9.3 Process Auxiliaries

The information in this section of the reference ABWR DCD, including all subsections, tables, and figures, is incorporated by reference with the following departures and supplements.

Figure 9.3-10 Breathing Air System Flow Diagram

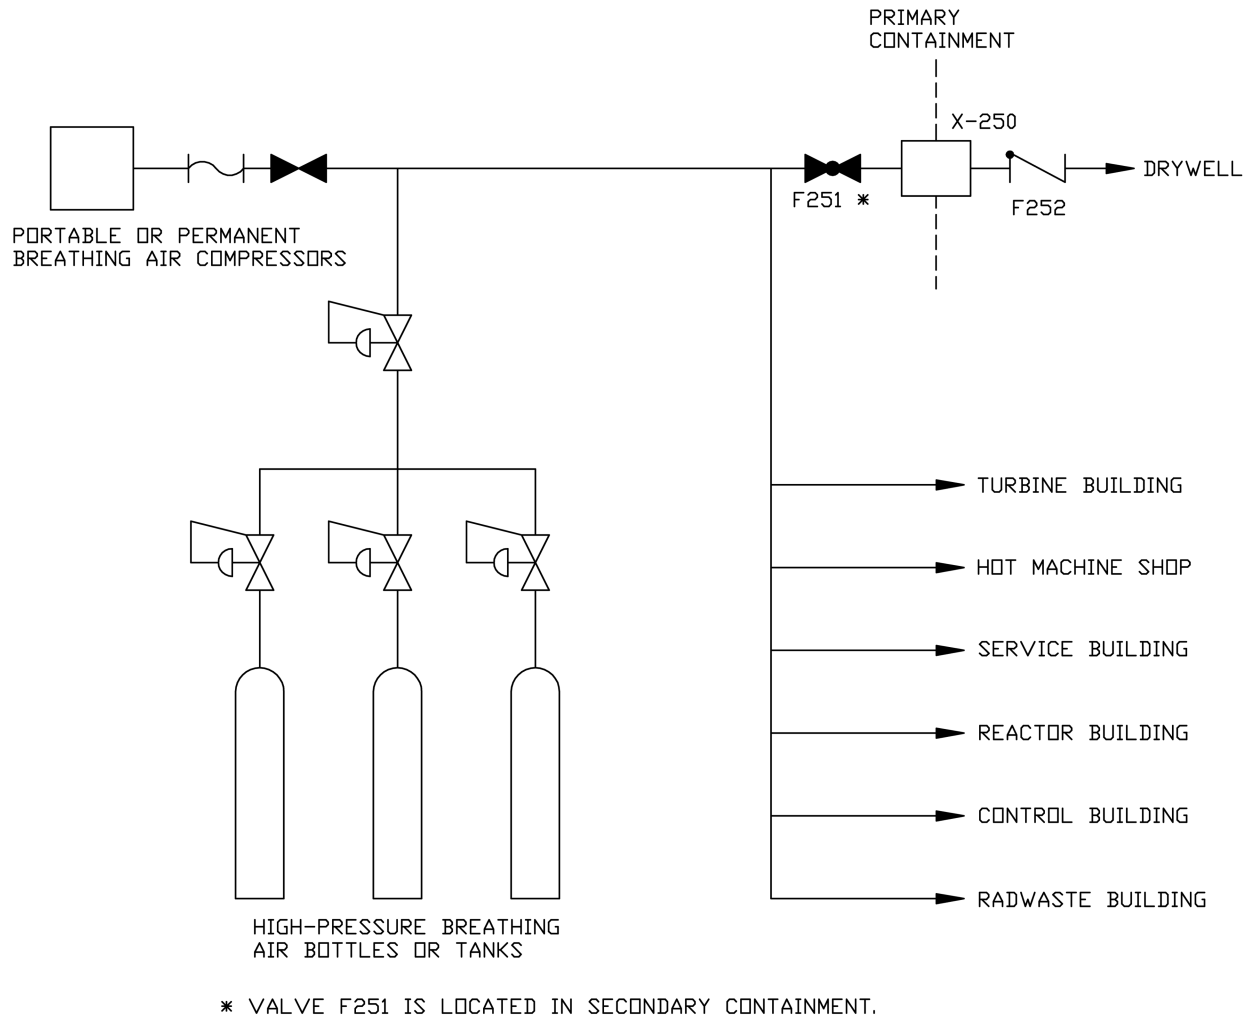
The BAS is sized to provide 100% ~~has two air compressors, each sized to provide 50%~~ of the peak air consumption using the bottled breathing air supply and a portable permanent breathing air compressor supply system, as needed. The compressors(s) ~~will be~~ ~~compressors are~~ of the oil-less, breathing air type.

The BAS is also ~~has one compressor~~ sized to charge high pressure self-contained breathing apparatus.

The ~~bottled breathing air supply and a portable or permanent breathing air compressor supply system, as needed~~ ~~air compressors~~ are operated during normal operation.

Outside ~~and inside~~ primary containment ~~a~~ manually-operated valves ~~is~~ ~~are~~ kept closed and locked during normal plant operation. During refueling, the valves ~~is~~ ~~are~~ opened to provide air inside the containment. ~~A check valve is provided inside the containment.~~ This arrangement meets GDC 56, Option (21).

Figure 9.3-12 Non-Radioactive Drainage System

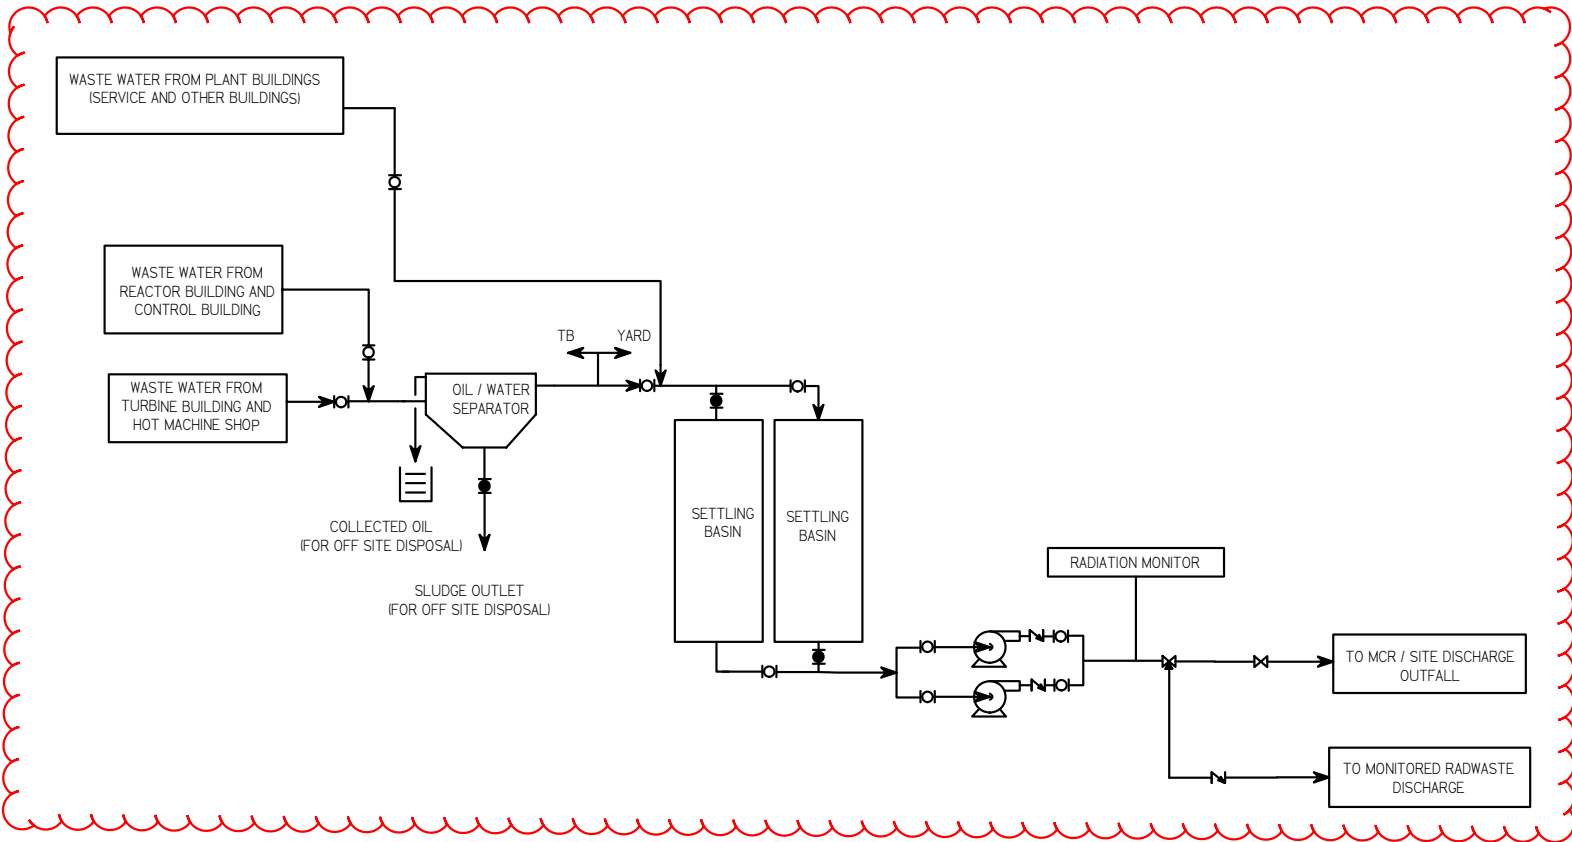
The design of the continuation of the non-radioactive drain system from the ABWR Standard Plant Buildings to the site discharge outfall is provided in Figure 9.3-12 and is discussed in this subsection.

The non-radioactive drain system collects waste water from plant buildings (Reactor, Turbine, Control, Service, and other buildings). A system composed of collection piping, curbs, and pumps is provided. Non-radioactive waste water from the Turbine Building, Reactor Building, hot machine shop and the Control Building is routed to a dedicated oil/water separator where oil and settled solids are removed for off-site disposal. The non-oily, non-radioactive effluent is sent to dual settling basins. Non-radioactive waste water from the Service Building and other buildings is sent directly to the dual settling basins. Means are provided to perform any required tests or

analyses required by the discharge permit. The non-radioactive liquid effluent is discharged to the Main Cooling Reservoir through permitted outfall(s). If radioactivity levels exceed the limits for discharge, the flow from the non-radioactive drains has the capability to be diverted to the radioactive effluent portion of the radwaste system. Normally, if low levels of radioactivity are detected, it is quantified and discharged via the normal outfall. Higher levels of radioactivity may require a permitted "batch" discharge via the radwaste effluent radiation monitor. The non-radioactive drainage system is illustrated in Figure 9.3-12.
